Section 12A Application No.Y/I-DB/2

For rezoning the permissible use from staff quarters to permit flats at Area 6f, Discovery Bay
Response to Comments (5)

Section 12A Application No.Y/I-DB/2 for rezoning the permissible use from staff quarters to flats at Area 6f
Applicant's response to the departmental comments made available by District Planning Office on 7 March 2017

Detail Study of Compensatory Trees

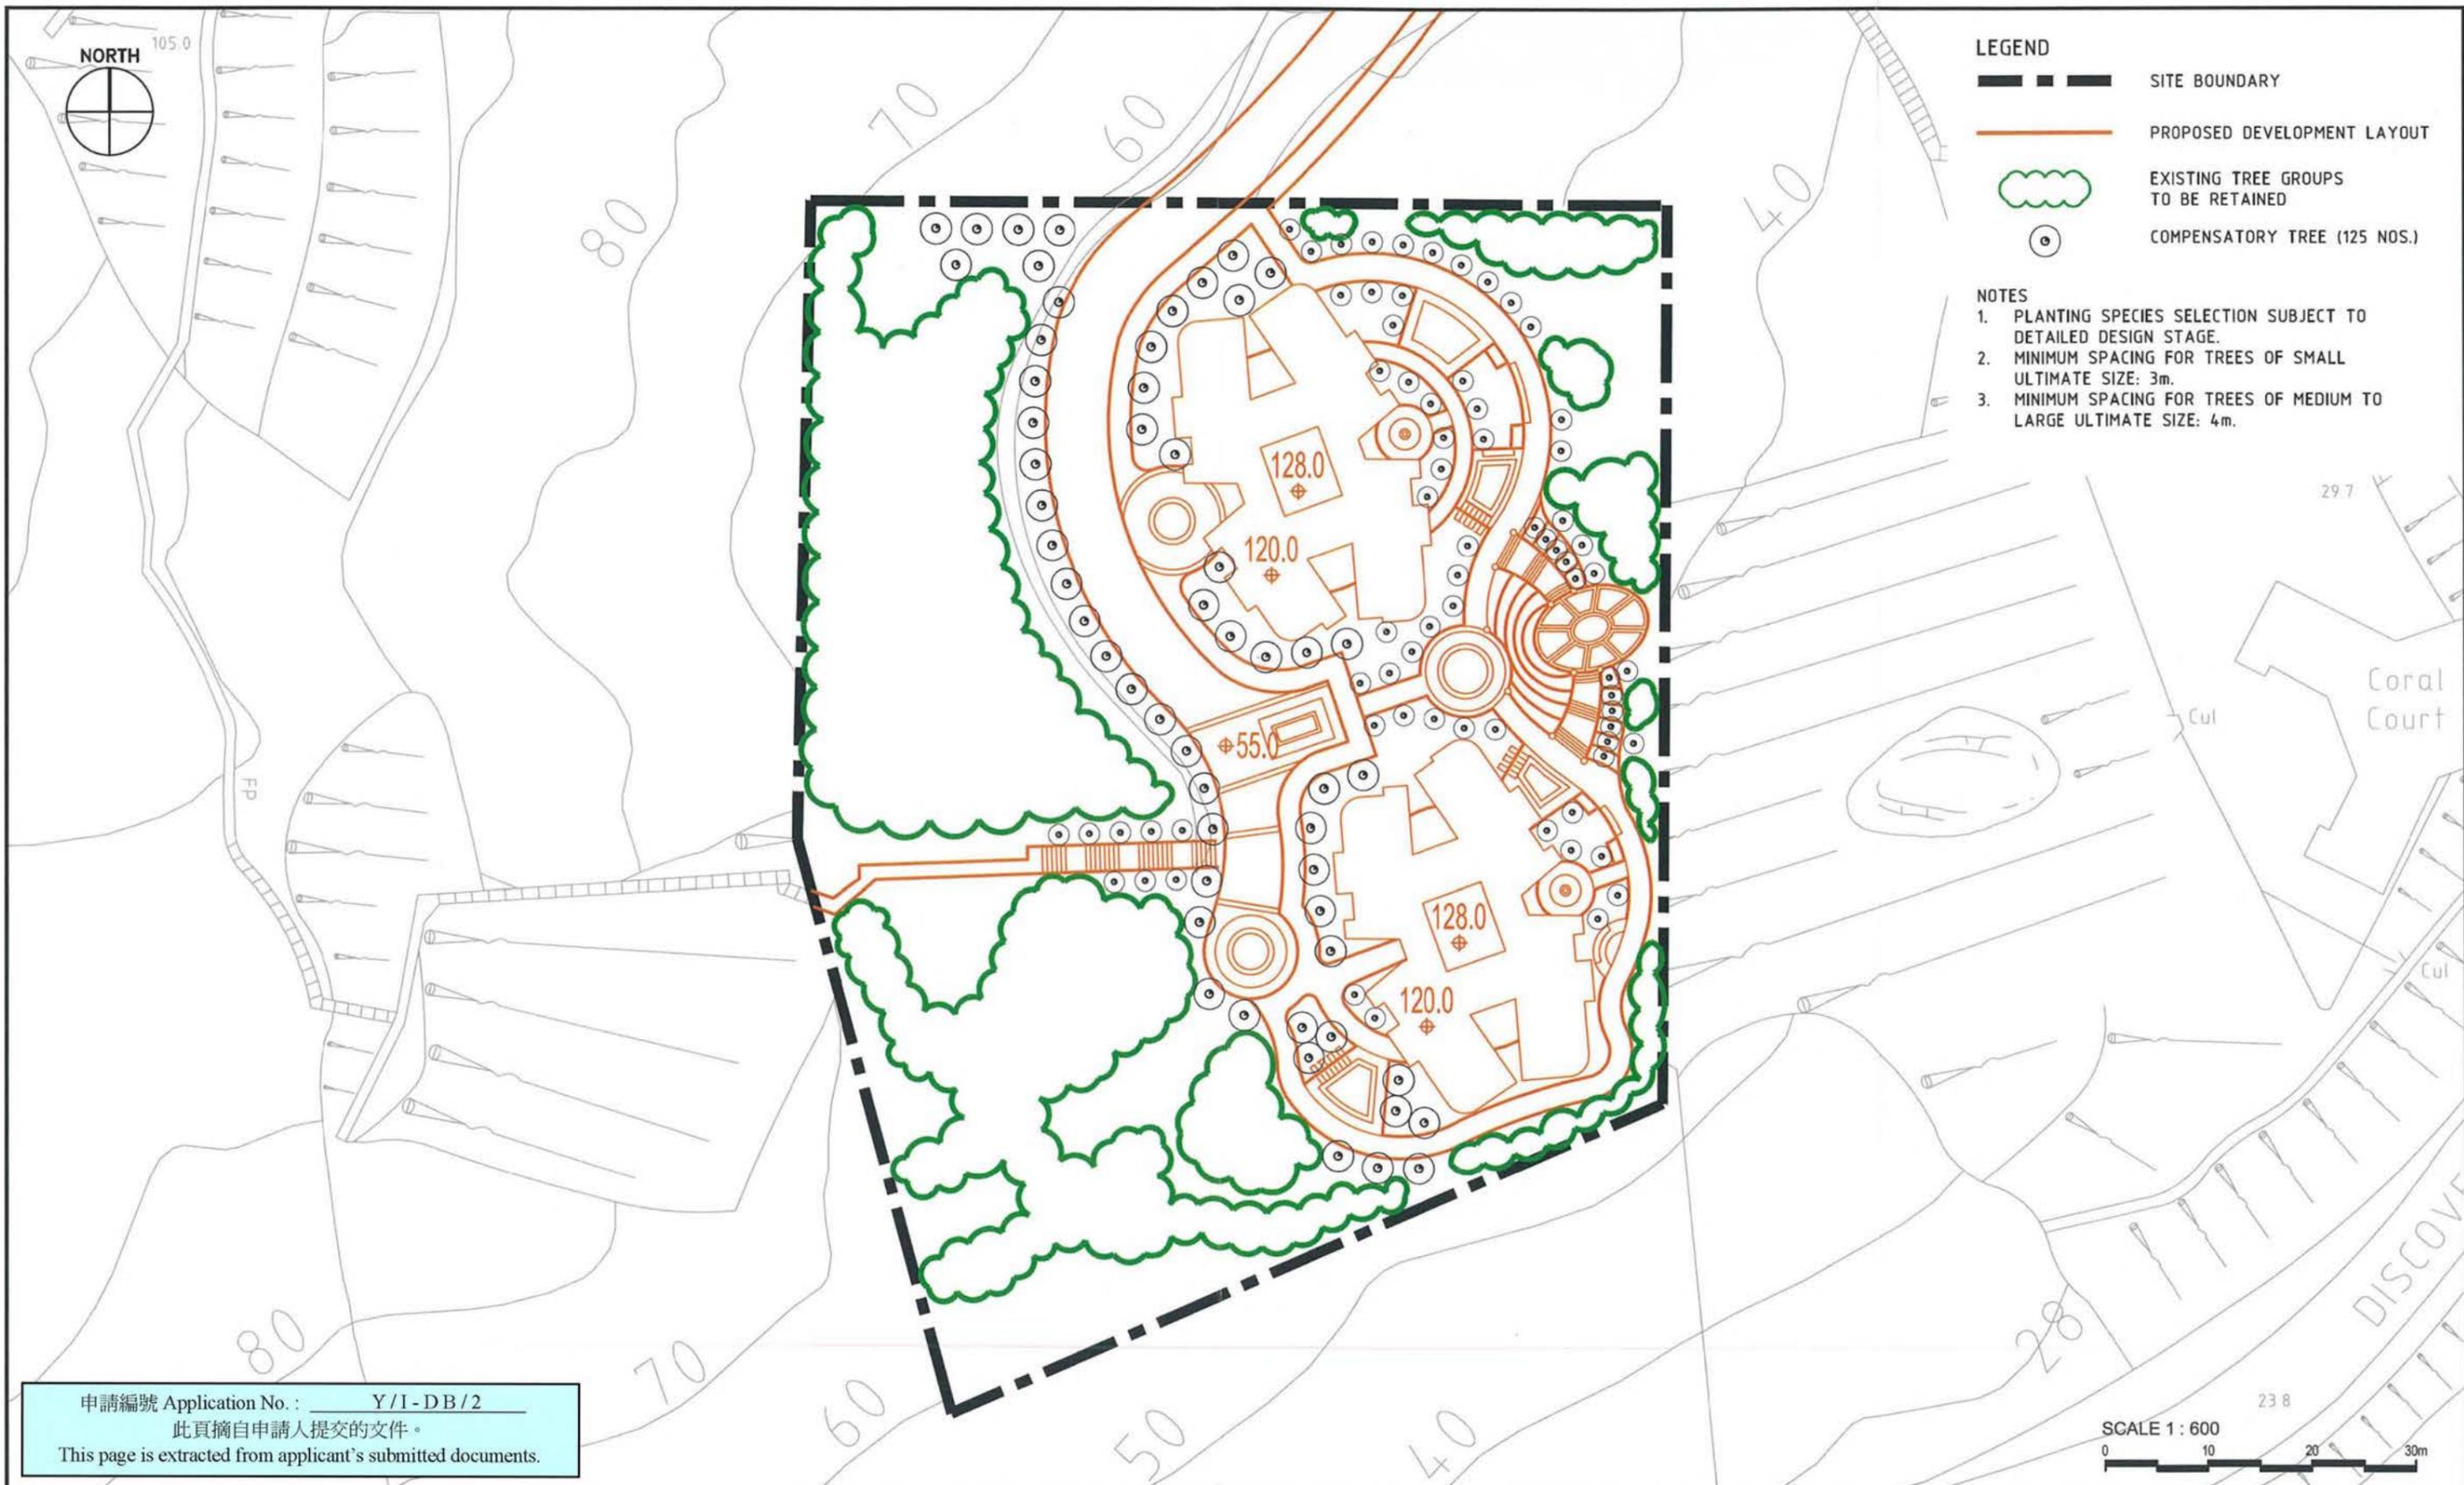
<p>CTP/UD&L, PlanD's comment</p> <p>Please note that under the 2nd FI there was an additional 98 nos. of compensatory trees proposed in the Landscape Design proposal (Rev. B) comparing to the Landscape Design proposal (Rev. 0). The revised proposal of 148 nos. compensatory trees was not clearly indicated in Fig B1 Landscape Design Plan. An insufficient planting space was also noted on the Landscape Master Plan (Figure B.1). We have doubt that if the development site could accommodate such large number of compensatory trees. The applicant should review critically the total number of compensatory tree planting within the site.</p> <p>The impact on existing trees is based on the assumption that no slope work is necessary. As the western slopes are quite steep, should the risk factor changed due to residential development and render slope work necessary, the scope of works and impact on trees should be re-visited.</p>	<p>Applicant's response</p> <p>The 148 no. compensatory trees were proposed for the total aggregate girth of the affected 118 no. trees. In view of this comment, a more detail study has been carried out as shown in Appendix B. It shows that about 125 no. compensatory trees definitely fit into the site with good separation distance. Detail design will possibly accommodate more compensatory trees at the site. The 125 no. compensatory trees are more than the 118 no. affected trees (and therefore achieve a greater than 1:1 compensatory ratio by number).</p> <p>Given the vegetated slopes within the site that will be retained, and the site context with large areas of existing woodland outside the site boundary, the 125 no. compensatory trees proposed are considered reasonable and adequate.</p> <p>Noted. The impact will be re-visited at building plans preparation stage.</p>
